ARCHITECTURAL ADDENDUM #03

ARCHITECTURAL ADDENDUM #04

Addendum Number Four (04)
PLANS AND SPECIFICATIONS FOR
Houston Community College – Culinary Arts Center
STANTEC Project No. 2140 00 169

February 13, 2017

AS.001

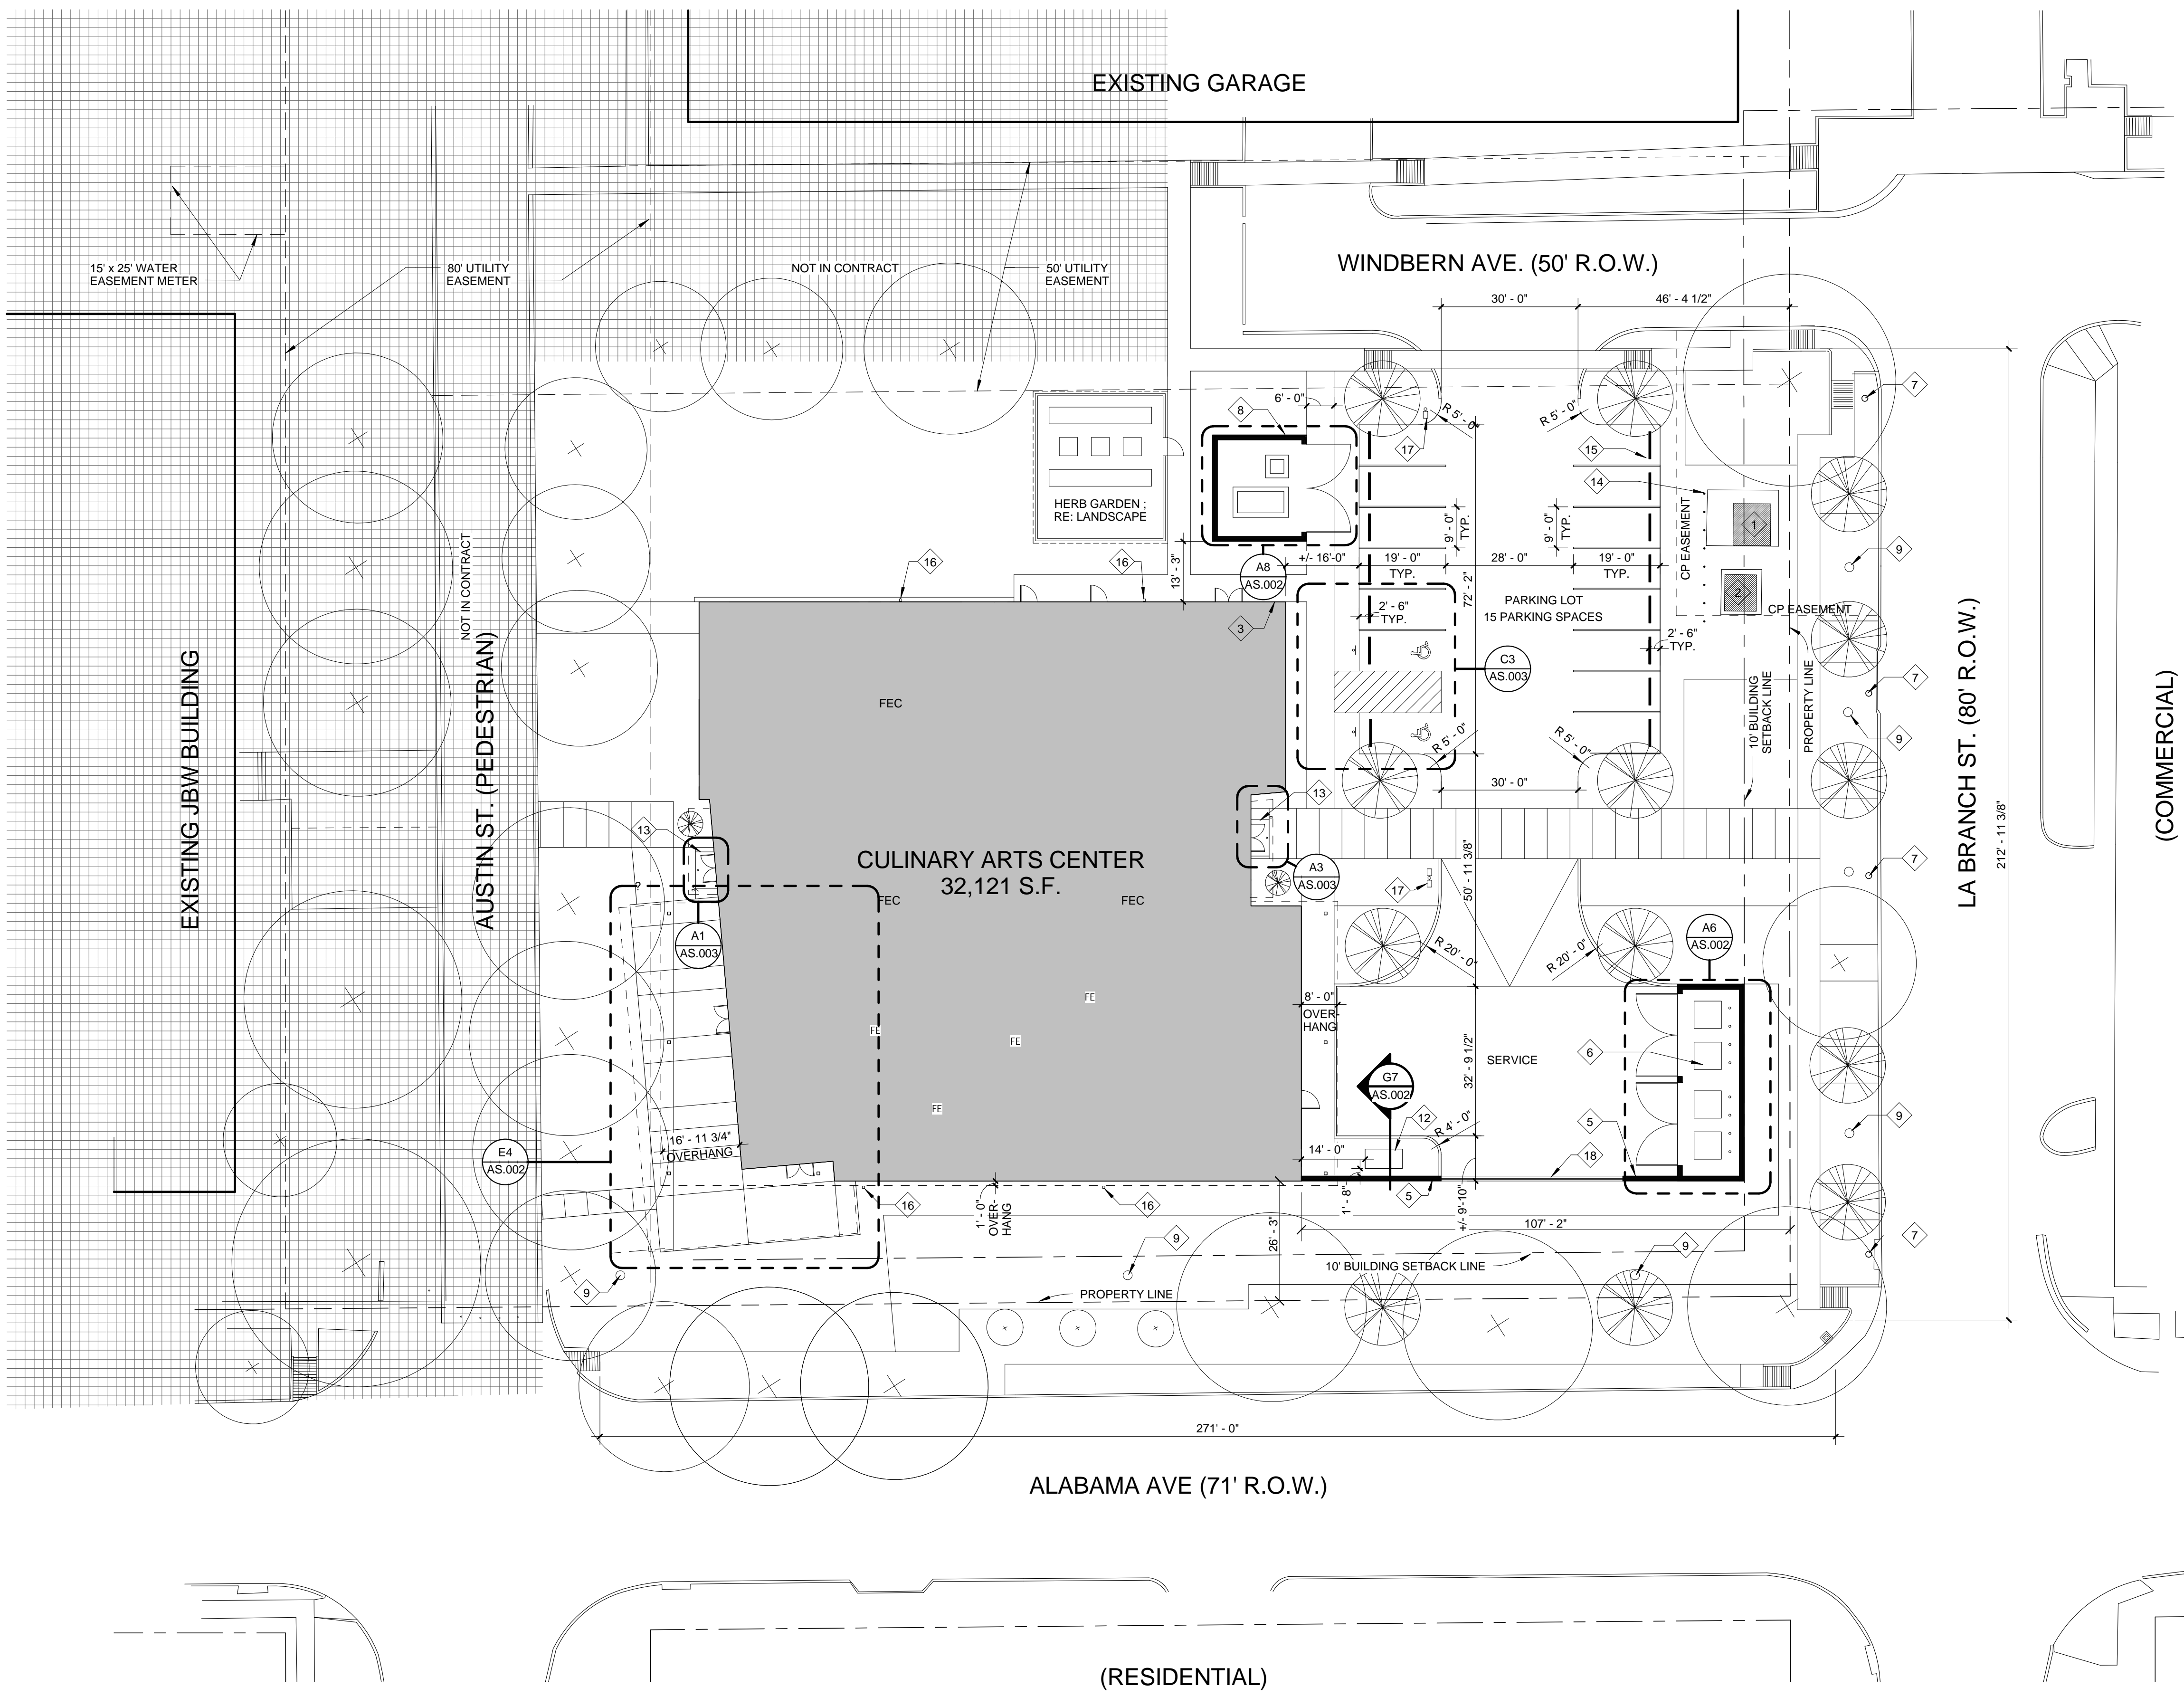
1. List of alternates has been added to this sheet

AS.002

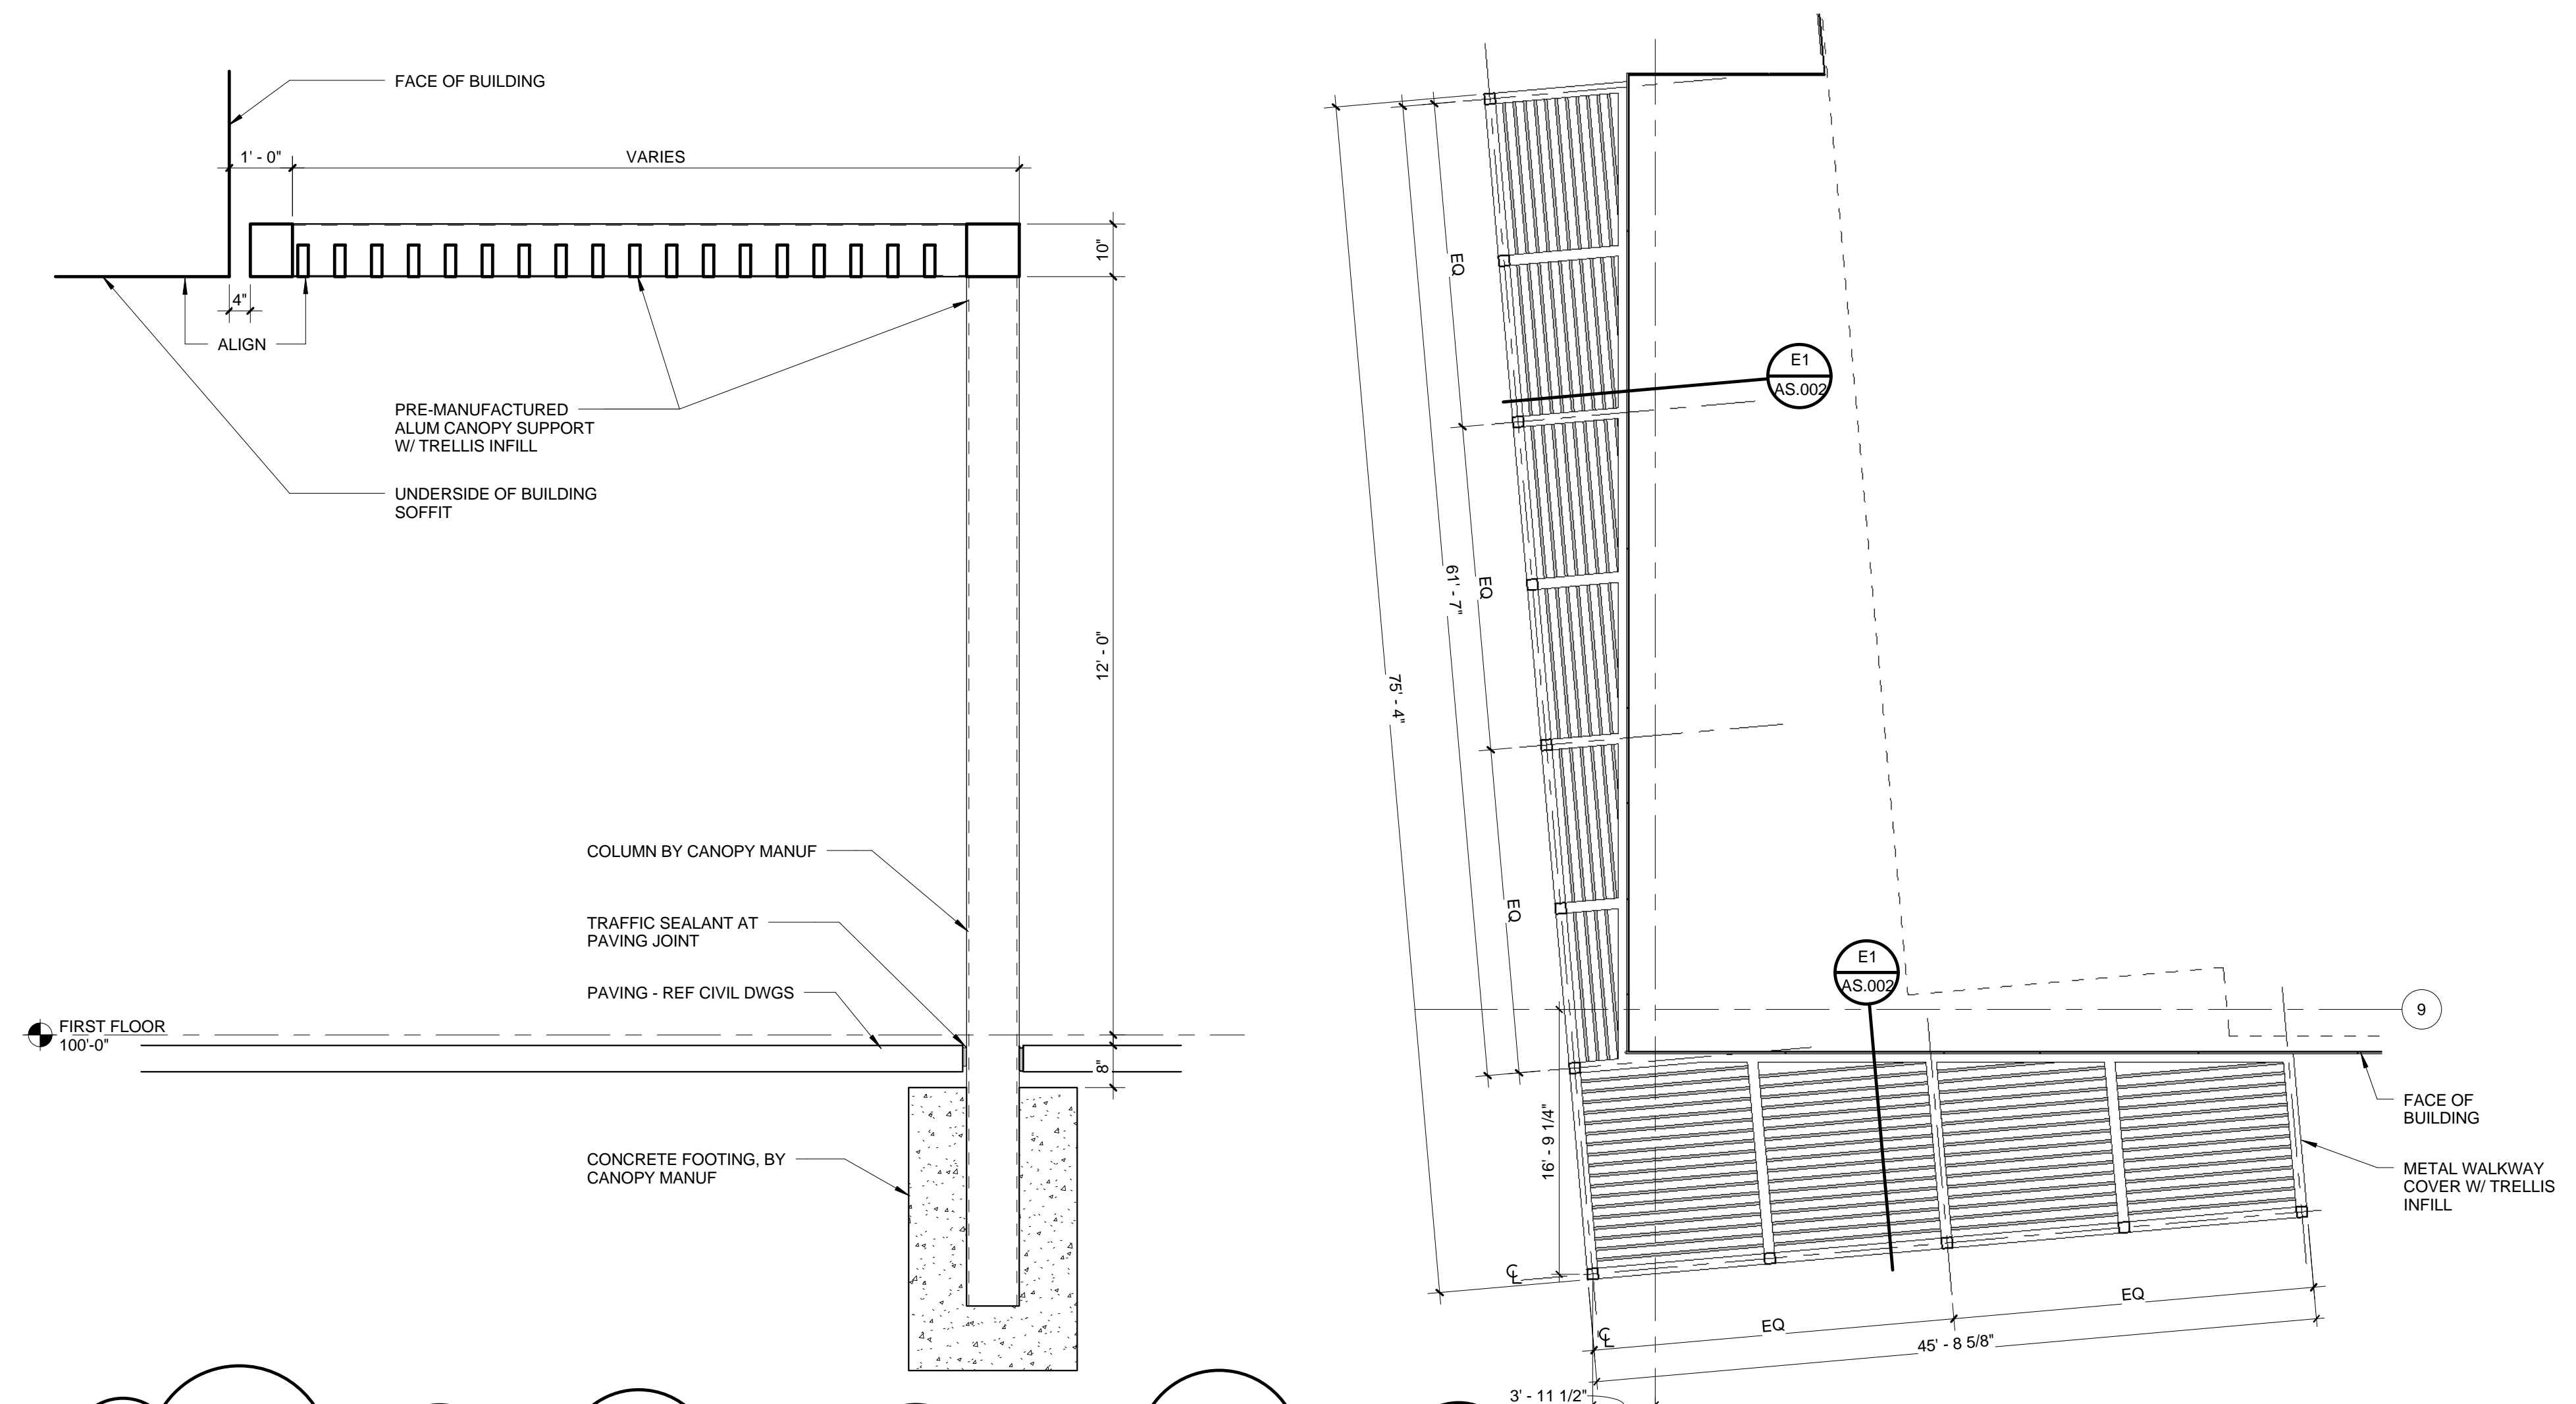
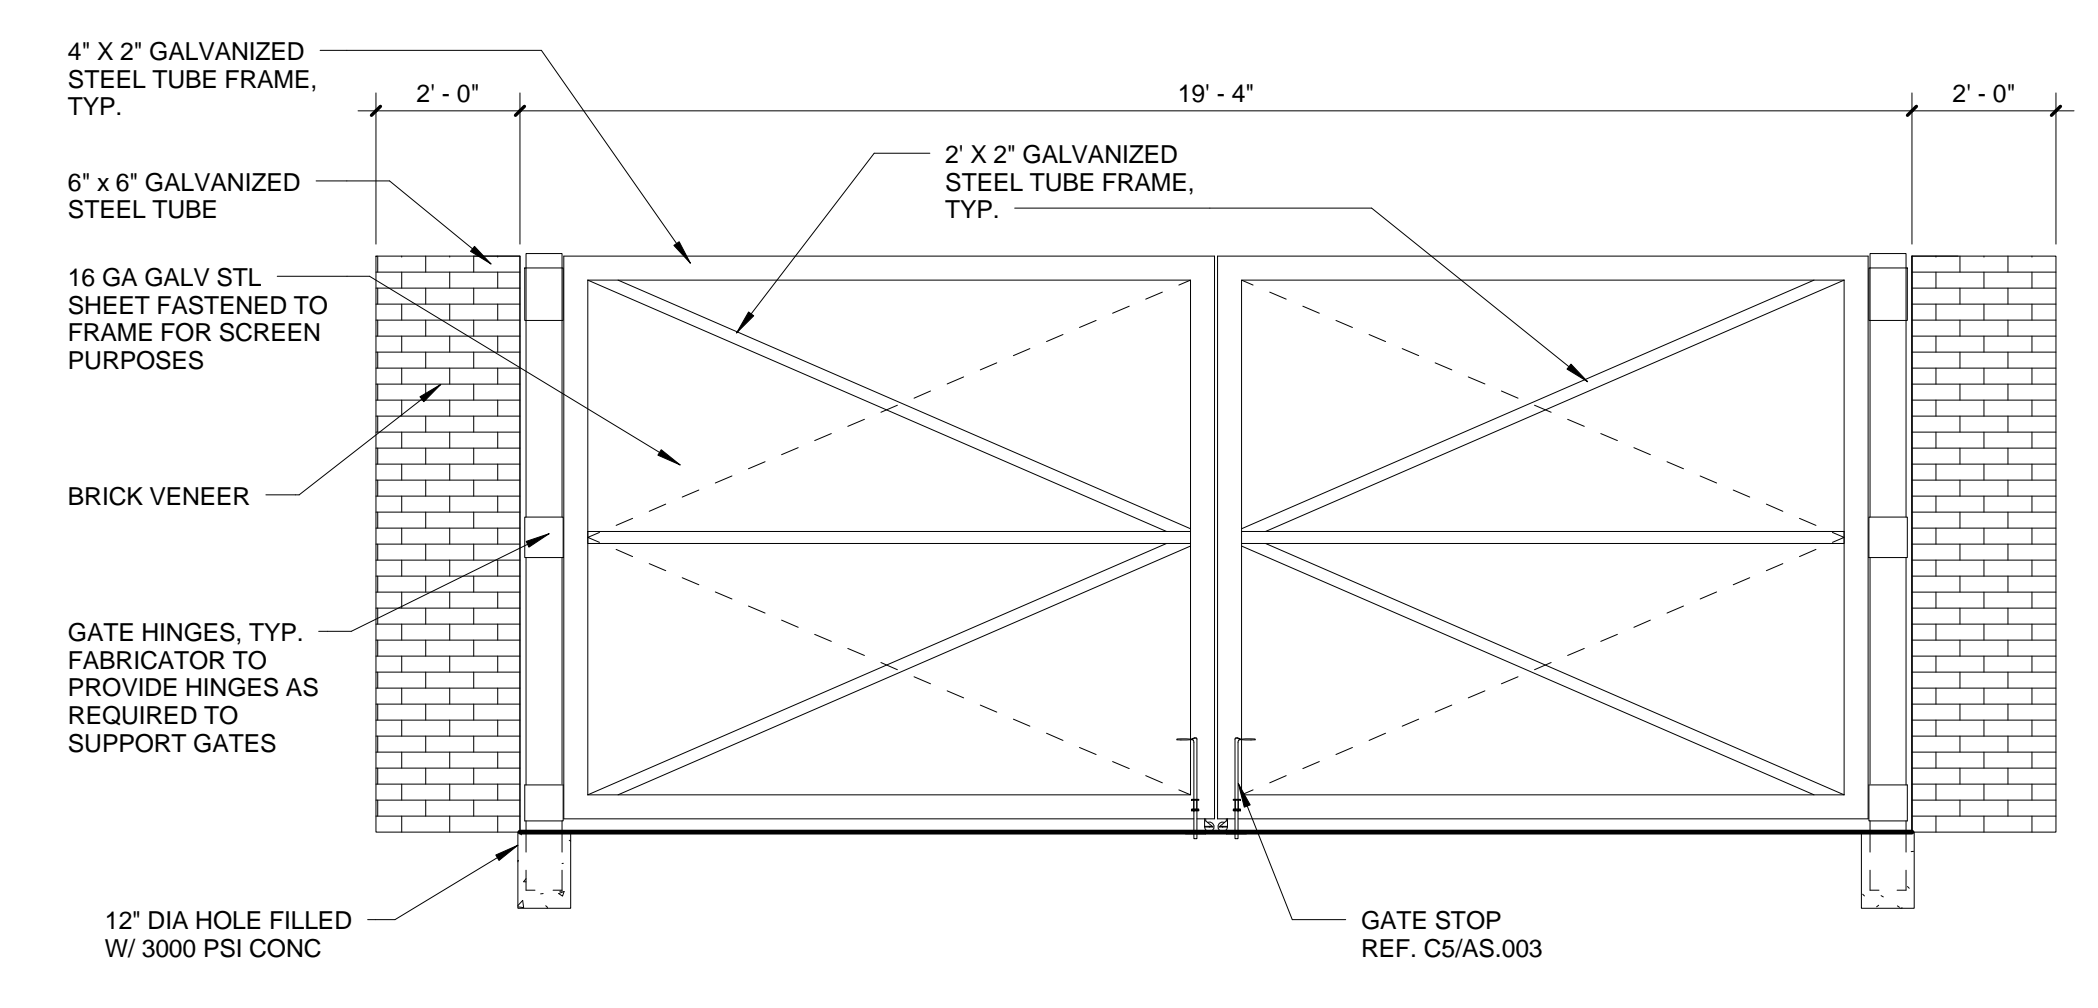
2. Added drawing titles for drawings relative to Alternate 1 (originally removed for Permitting)
